**Re: El Segundo Power Redevelopment Project 00-AFC-14C
Responses to Data Requests, Set 2**

Responses to CEC Data Requests, Set 2 El Segundo Power Redevelopment Project

00-AFC-14C

Responses to CEC Data Requests Set 2

FIGURE 1: BEACH DELIVERY CORRIDOR

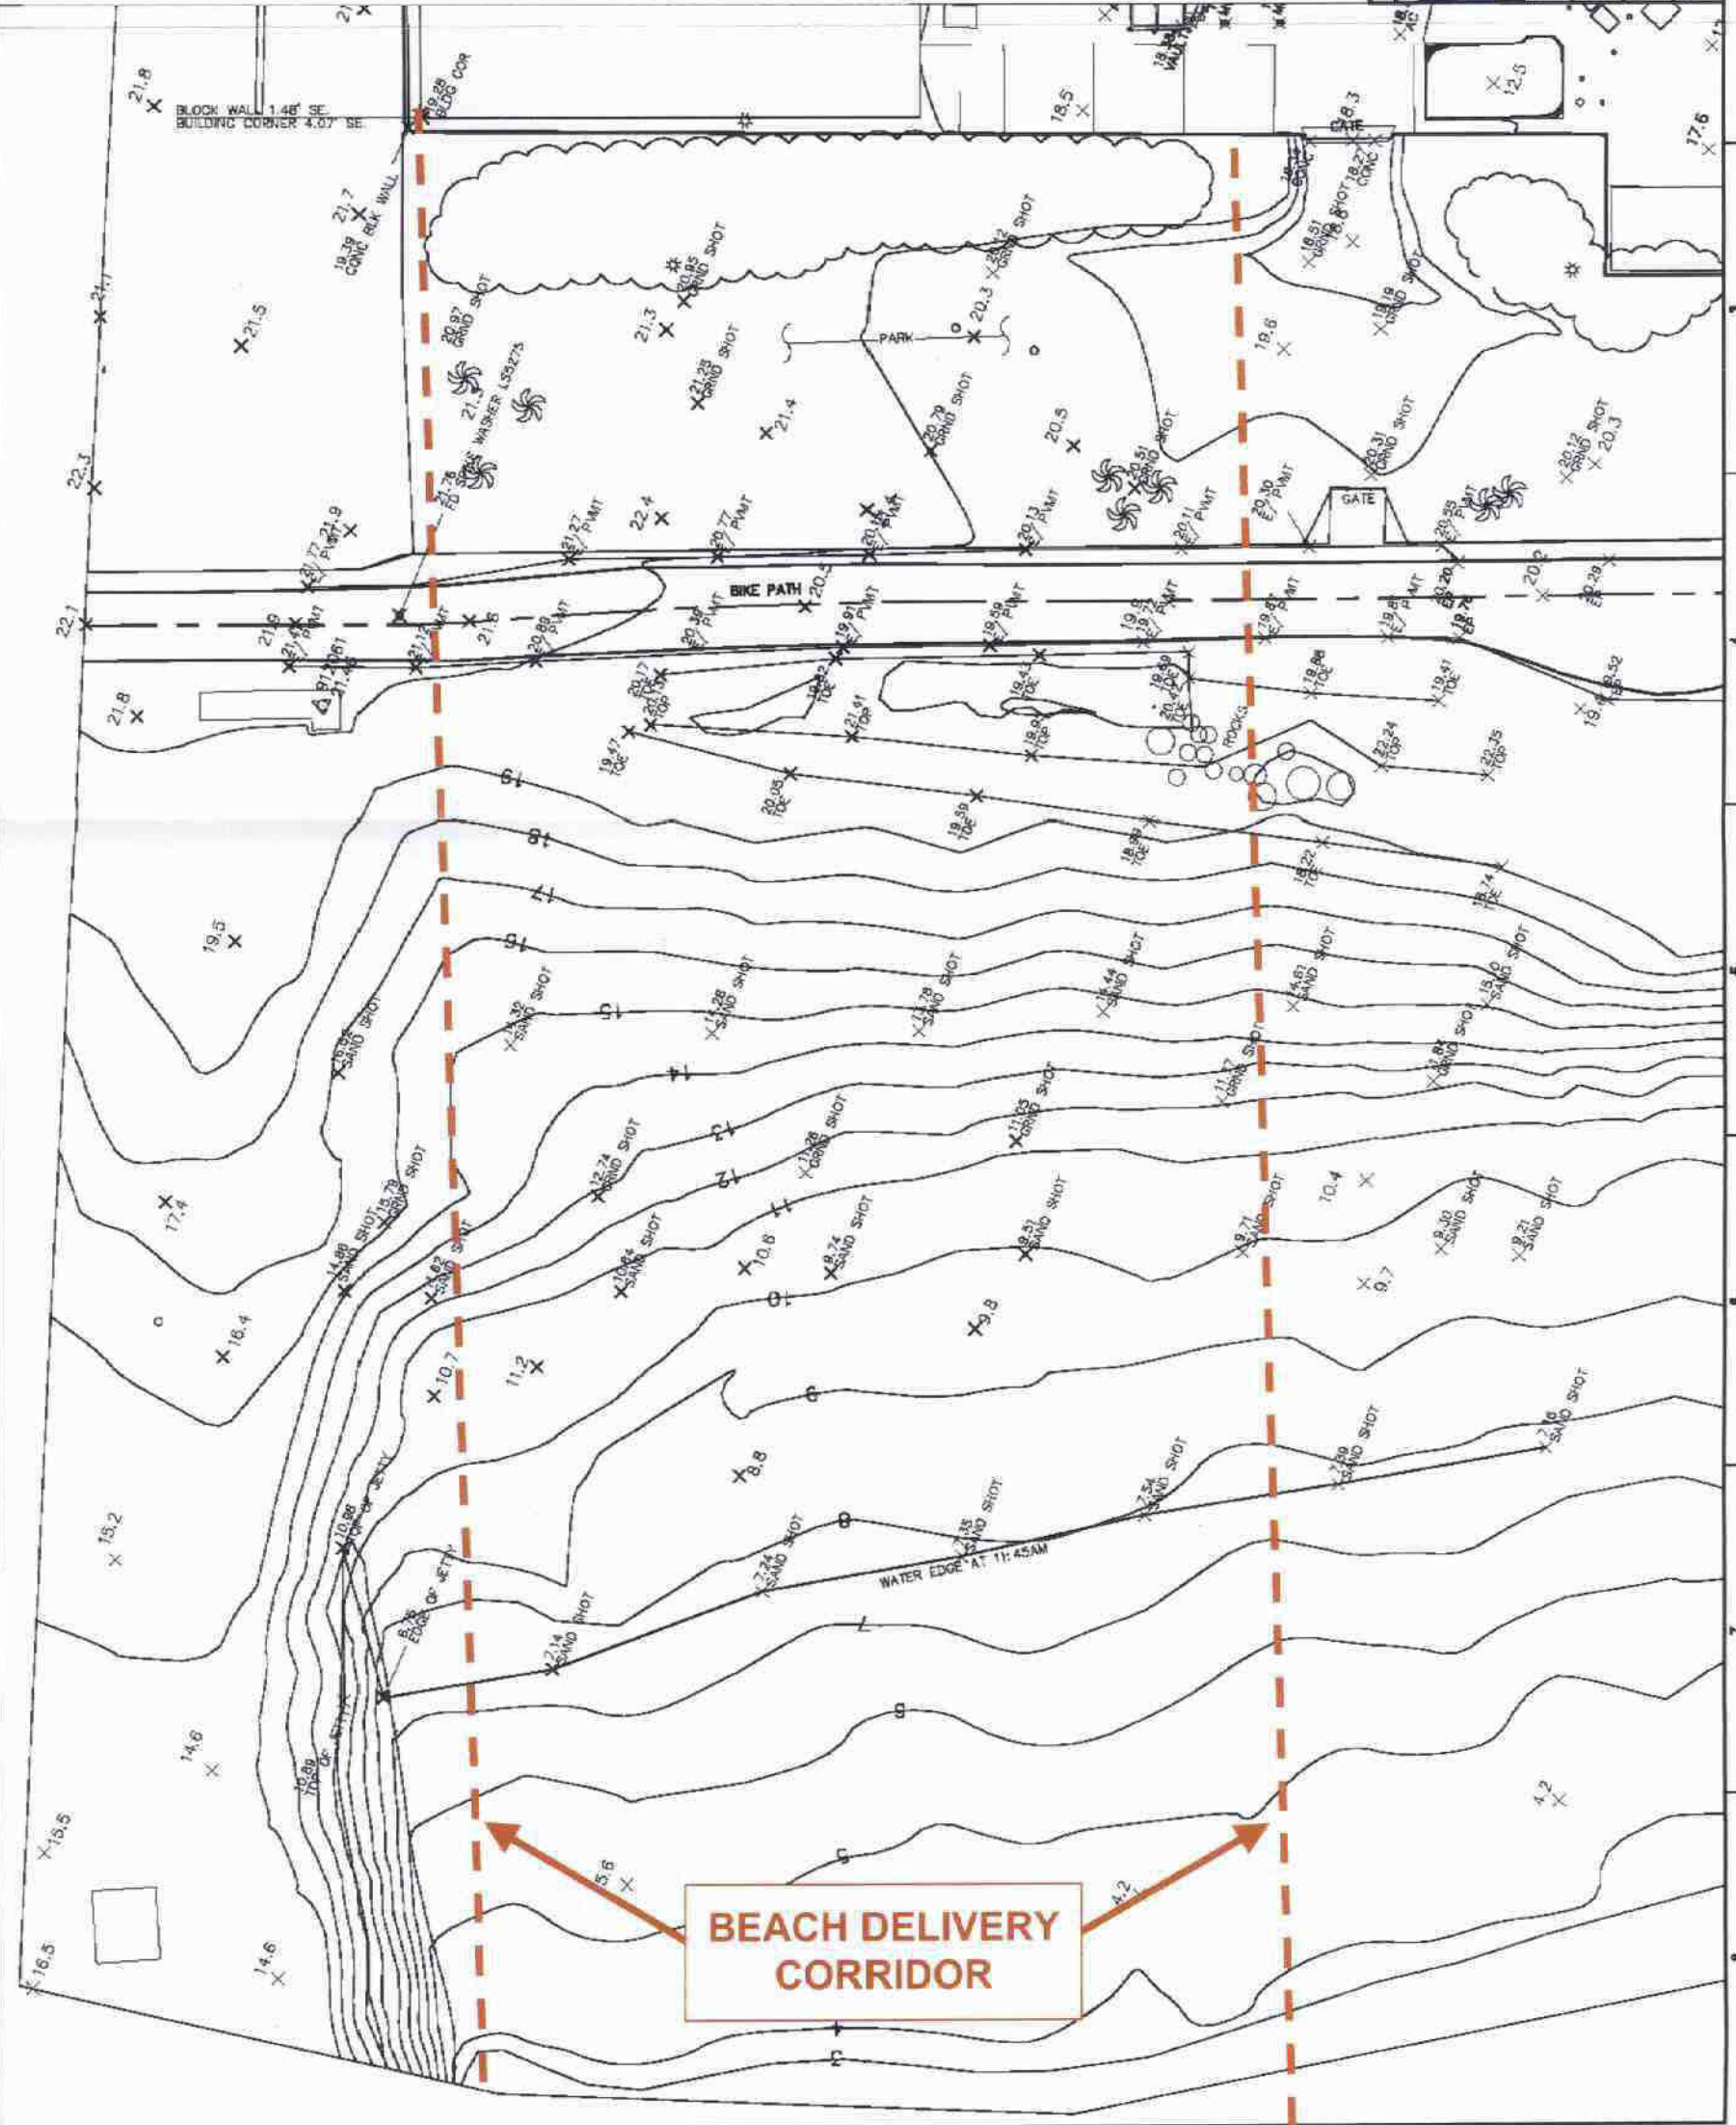
Data Request 11 Please provide a draft DESCP containing elements A through I below outlining site management activities and erosion/sediment control best management practices (BMPs) to be implemented during site mobilization, excavation/demolition, construction, and post-construction activities. Within the draft DESCP, please provide a discussion of the requirements of any additional municipal permits issued by the LARWQCB for separate storm sewer systems. The level of detail in the draft DESCP shall be commensurate with the current level of planning for site demolition and corresponding site grading and drainage. Please provide all conceptual erosion control information for those phases of construction and post-construction that has been developed or provide a statement of when such information will be available. The DESCP is to be a separate document from the construction SWPPP and will be updated and revised as the project moves from the preliminary to final design phases.

Currently, the Beach Delivery Erosion and Sediment Control Plan (COC WQ-11) exists in a preliminary draft format (see Appendix M). In order to finalize the Beach Delivery ESCP, the 401/404 permitting process will need to be completed, and the Nationwide Permit 33 Restoration Plan will need to be developed and approved by the Army Corps of Engineers. Once the federal
